February 13, 1992

Subject: Proposed SCSI Identifier Symbols

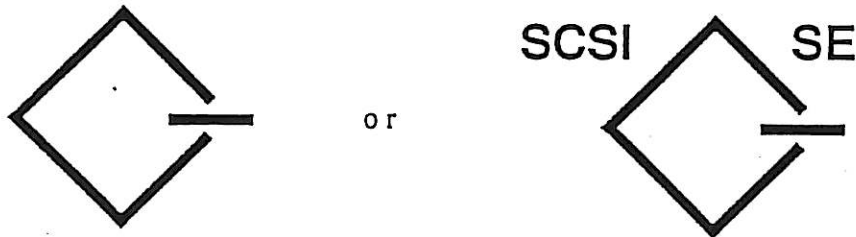
We propose that the present icon as recommended by the SCSI committee with the single lined diamond be preserved for the single ended SCSI implementation.

We propose that this symbol be modified from a single lined diamond to a double lined diamond to indicate the differential SCSI interface.

Single-Ended SCSI Icons.

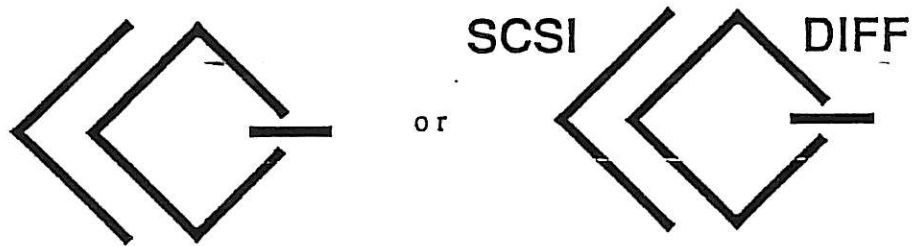
We also suggest that an additional text string be optionally attached to these symbols as described in the 91-49, Rev.1 proposal for improved visual identification. There should not be any restriction on size, font, and position of the string. The string could be positioned as a single line or diagonally. The only criterion should be optimal visibility.

On molded connectors, it might even be possible to feel the difference between the symbols by simply brushing over it with a finger nail in places with a restricted visibility.

This proposal has two merits. It would preserve the old symbol for single ended SCSI and still make it possible to distinguish between the two interface categories both visually and tactilely.
